AUTHORIZATION TO CONDUCT NEXT FLOOD MEASURES

Project Number: SA-3-133-2015

Project Location: Plainfield Road - Gunner Brook

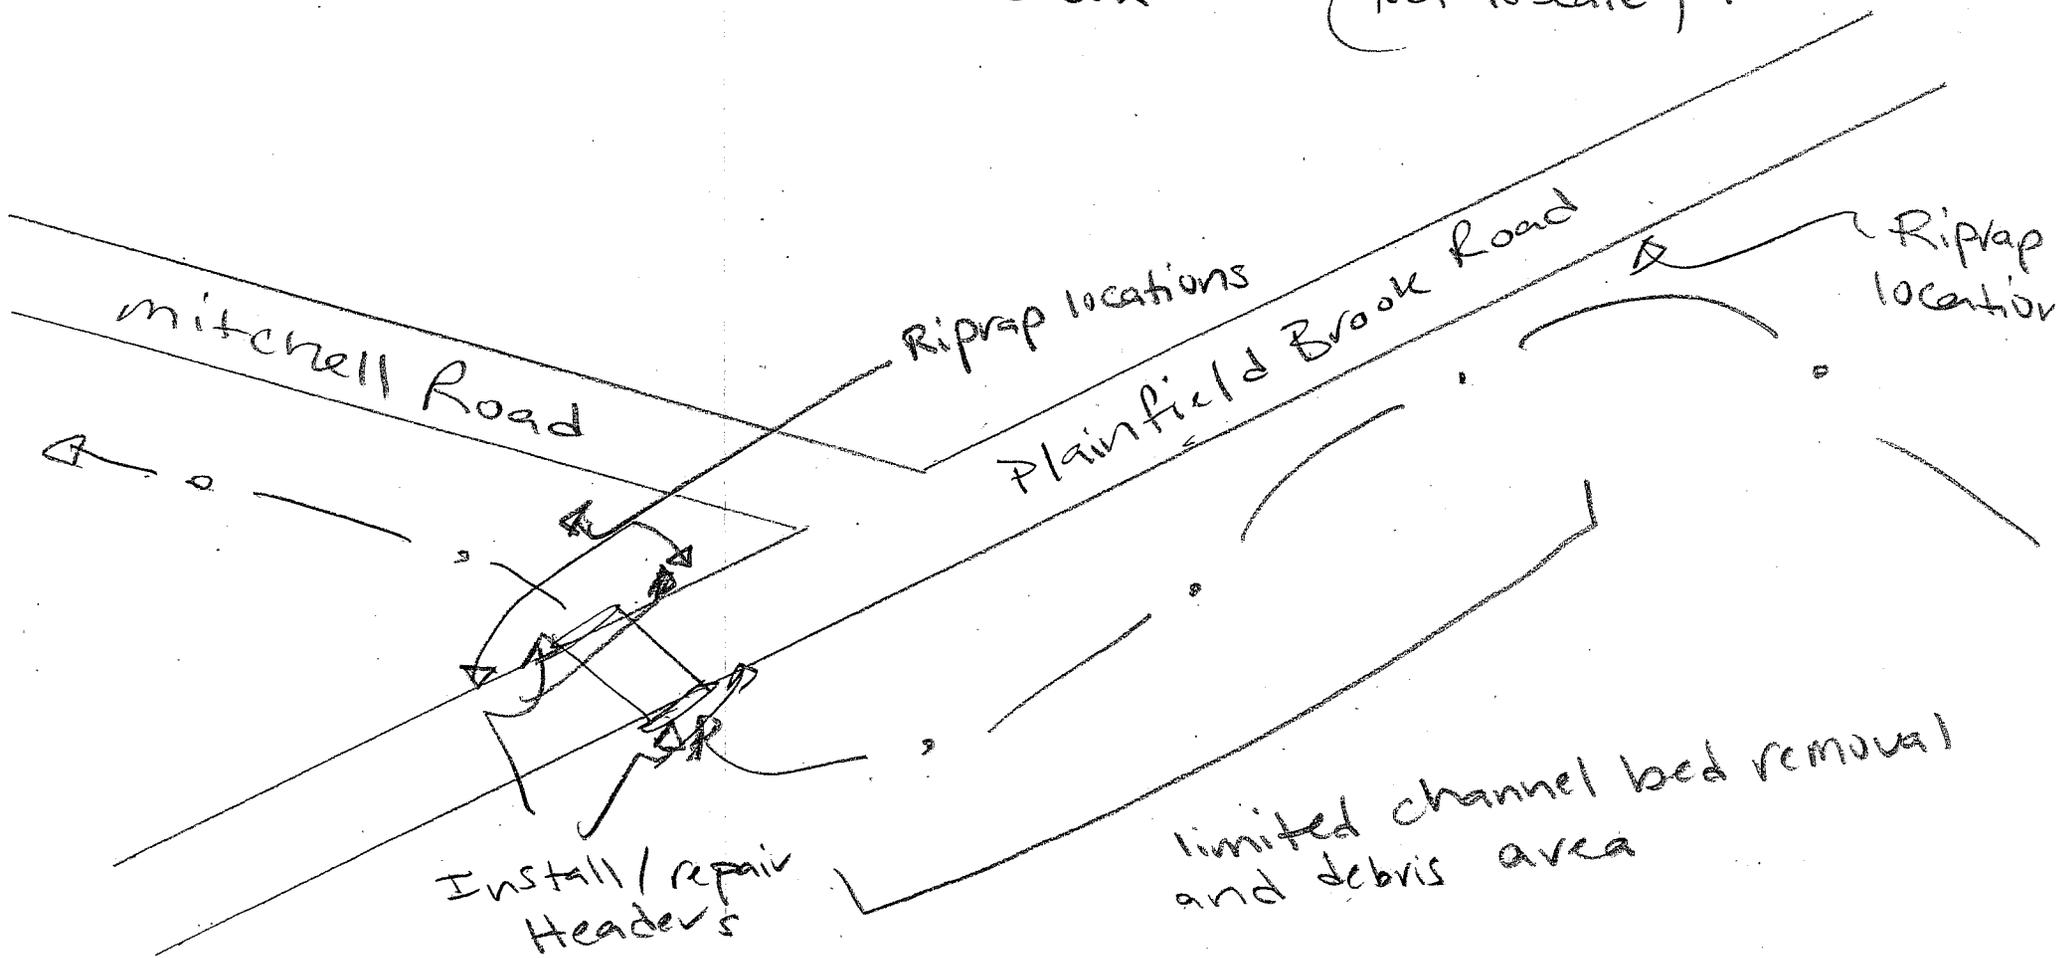
- **Stream crossing structure is undersized and should be replaced with bankfull plus sized structure.** Current structure is size at approximately 50% of bankfull width. A new bankfull plus sized structure would better accommodate the passage of flow, sediment and debris, reducing jam potential and related outflanking. DEC Stream Engineers and VTrans available to assist in correct structure sizing.
- **Rock-lined drainage ditches-** install rock lined drainage ditch stabilization on upstream road drainage networks as needed to address erosion.

Town of Barre - Plainfield Brook Rd.

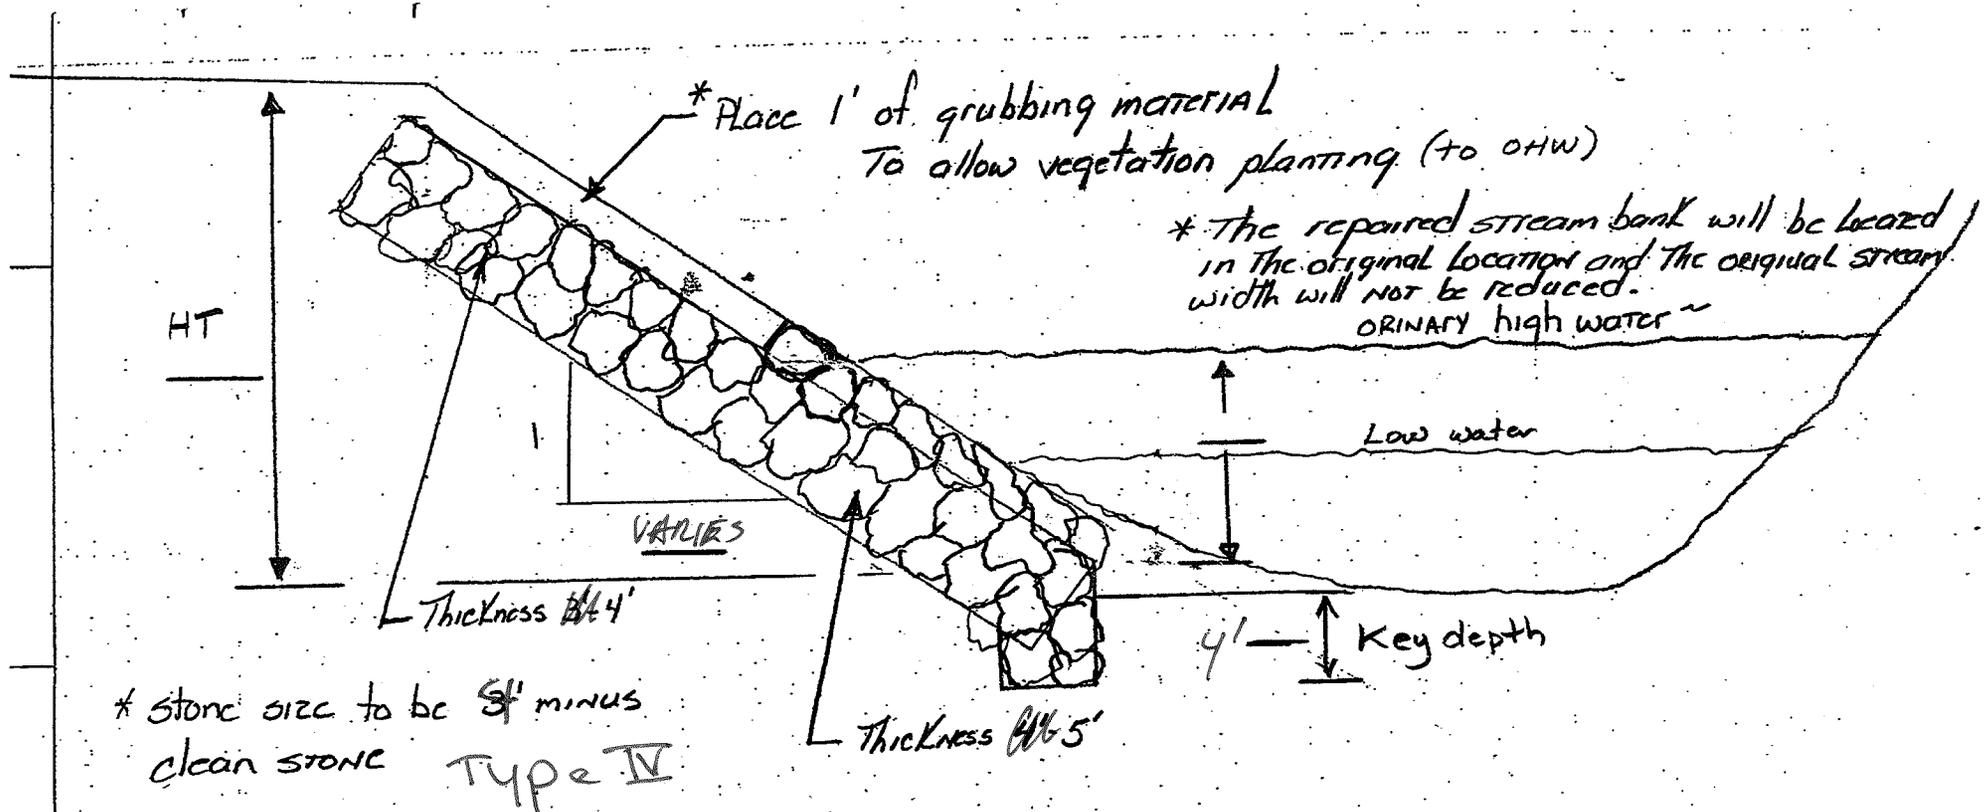
Riprap locations

Riprap location

Install/repair Headers

limited channel bed removal and debris area

streambank protection
w/ Keyed Toe
